# UNITED STATES PATENT AND TRADEMARK OFFICE

APPLICATION NO.	FILING DATE	FIRST NAMED INVENTOR	ATTORNEY DOCKET NO.	CONFIRMATION NO.
10/789,929	02/27/2004	Eric S. Cole	079361-9034-01	6802
23409	7590	08/31/2005	EXAMINER	
MICHAEL BEST & FRIEDRICH, LLP 100 E WISCONSIN AVENUE MILWAUKEE, WI 53202			EDGAR, RICHARD A	
			ART UNIT	PAPER NUMBER
			3745

<b>Office Action Summary</b>	Application No.	Applicant(s)
	10/789,929	COLE ET AL.
Examiner	Art Unit	
Richard Edgar	3745

## DETAILED ACTION

**FIG. 1**

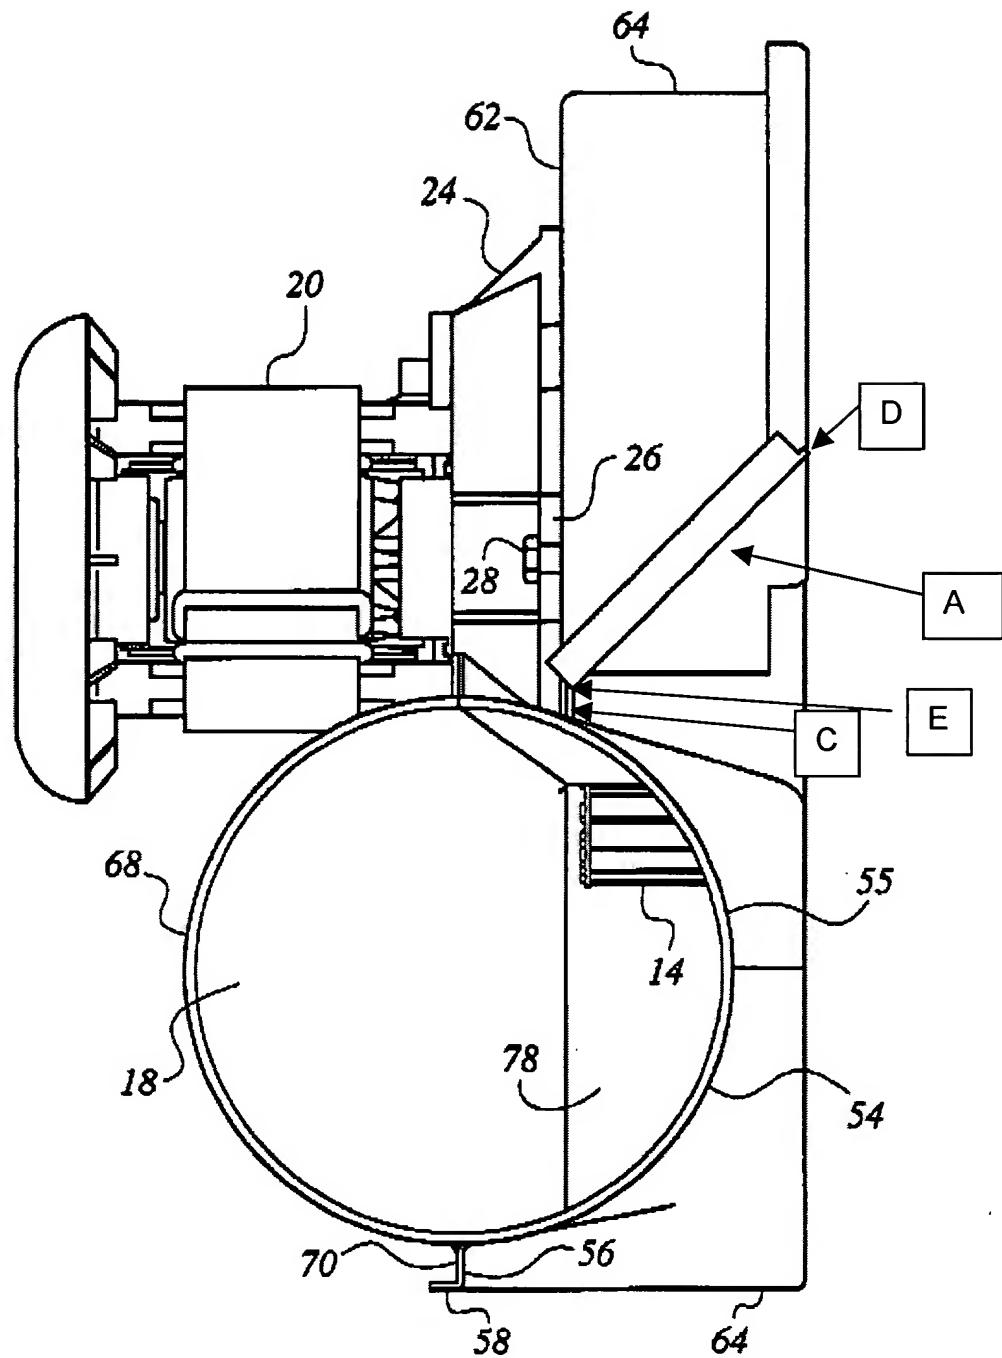
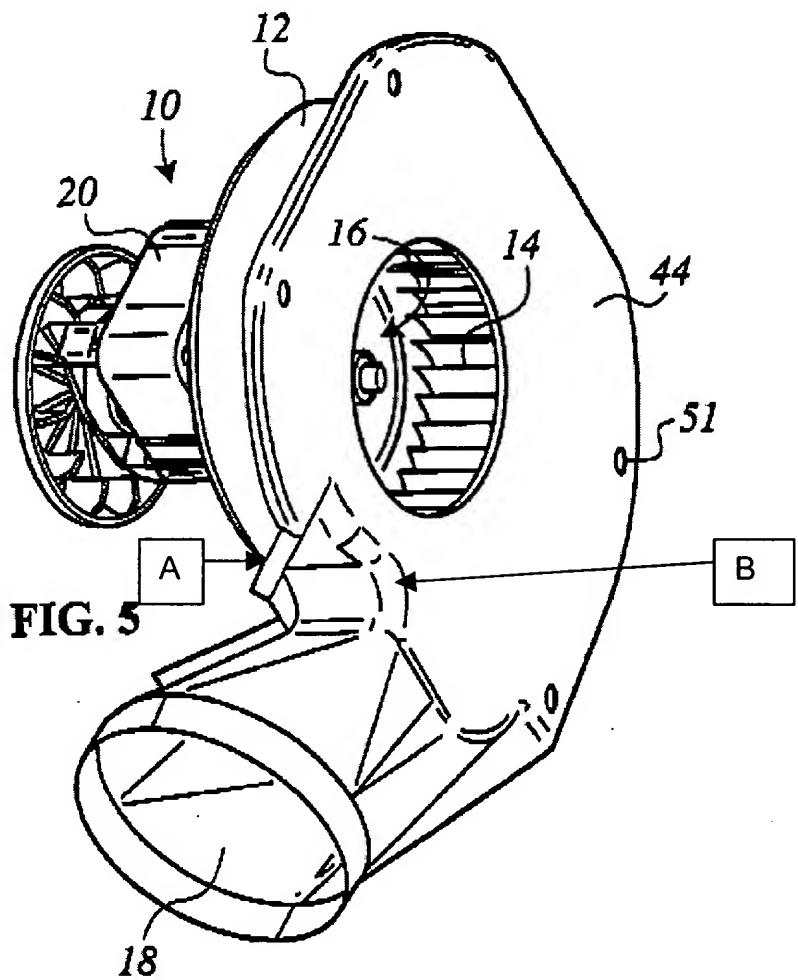
Garrison et al. teach a fan housing for a fan rotatable about an axis, the fan housing comprising: a first housing component 40 at least partially defining an internal chamber 32 adapted to receive the fan 14; and an inlet wall 44 having an inlet aperture 16 through which fluid enters the fan housing; the first housing component 40 comprising a transition section 55 extending away from the inlet aperture 16 toward an exhaust outlet 18 and through which fluid passes from the internal chamber 32 to the exhaust outlet 18; an axially-extending side wall 52 located adjacent the exhaust outlet 18; a second housing component 42 complementary to the first housing component 40 and at least partially defining the internal chamber 32, the second housing component 42 comprising a transition section 54 extending toward the exhaust outlet 18 and through which fluid passes from the internal chamber 32 to the exhaust outlet; and a side wall 64 extending axially toward the first housing component 40 and shaped complementary to the axially-extending side wall 52 of the first housing component 40; and a housing seam 60 defined between the side wall 52 of the first housing component 40 and the side wall 64 of the second housing component 42, the seam having a length extending at least partially about the axis while extending axially (see annotation A).

The fan housing further comprises a cutoff (see annotation B) located adjacent the exhaust outlet 18 and defining high and low pressure areas at different circumferential positions about the axis; wherein the seam 60 runs about the axis from one side of the exhaust outlet to another side of the exhaust outlet, and the cutoff (B) is located between the exhaust outlet 18 and the length of the seam extending at least partially about the axis while extending axially (A).

The seam 60 extends from an axial location substantially co-planar with the inlet wall 44 (see Fig. 7) to an axial location disposed from the inlet wall (see Fig. 4).

The second housing component 42 further comprises a wall 22, 62 spaced a distance from the inlet wall 44 to at least partially define the internal chamber 32; and the seam 60 extends from an axial location (see annotation C) substantially co-planar with the wall 22, 62 of the second housing component 42 to an axial location disposed from the wall of the second housing component (see Fig. 4).

The length of the seam A extends about less than a majority of the circumference of the side walls (see Fig. 1); and another length of the seam extends about another portion of the circumference of the side walls (see Fig. 6).

The length of the seam extending at least partially about the axis while extending axially A runs in a direction away from the inlet wall 44 with increasing proximity to the exhaust outlet 18 (see Fig. 4).

The side wall 64 of the second housing component 42 extends about the axis and ends a distance short of the cutoff B.
